**COMMISSION OF ARCHITECTURAL REVIEW
STAFF REPORT
August 28, 2018 Meeting**

8. COA-039289-2018 (M. Jarreau)

517 North 26th Street
Church Hill North Old and Historic District

Project Description: **Reconstruct existing front porch,
construct a two-story addition at the rear of the existing structure,
and add two windows on the right side elevation.**

517 N. 26th Street - Right Elevation.

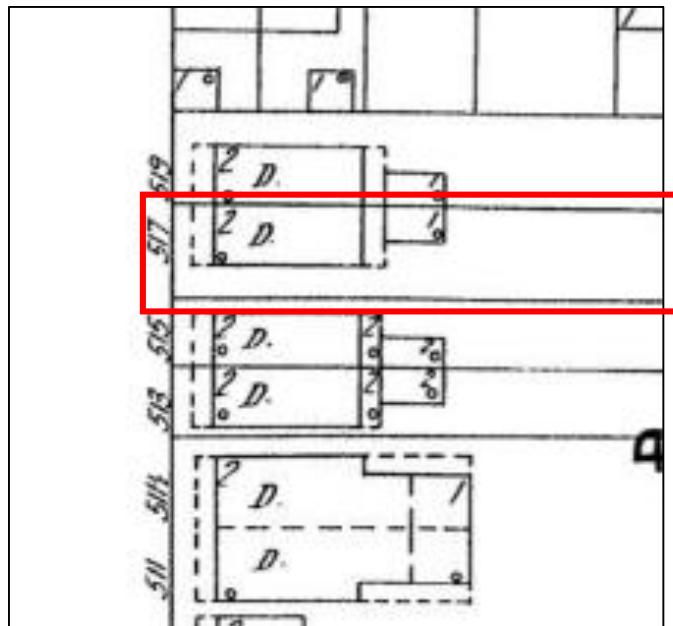
3. Construction of a two-story addition on the rear elevation. Staff finds the new addition is located to rear of the building and will be as inconspicuous as possible due to site constraints (pg. 46 #1). Staff recommends the insertion of two narrow, stacked windows on the projecting bay on the north facing elevation to be in keeping with other fenestration patterns for projecting bays found in the district. Staff further recommends the fenestration pattern on the right side elevation be consistent, notably that windows “F” replicate windows “C”.

4. Insertion of new windows into the solid masonry wall. Staff finds the removal of original features and materials and the insertion of new window openings in masonry walls are not keeping with the Guidelines (pg. 59 #1 and pg. 69 #8).
5. The use of PVC-clad windows. Staff recommends either wood or aluminum-clad windows be utilized (pg. 69 #s10-11). Staff recommends the window materials be submitted for administrative approval.
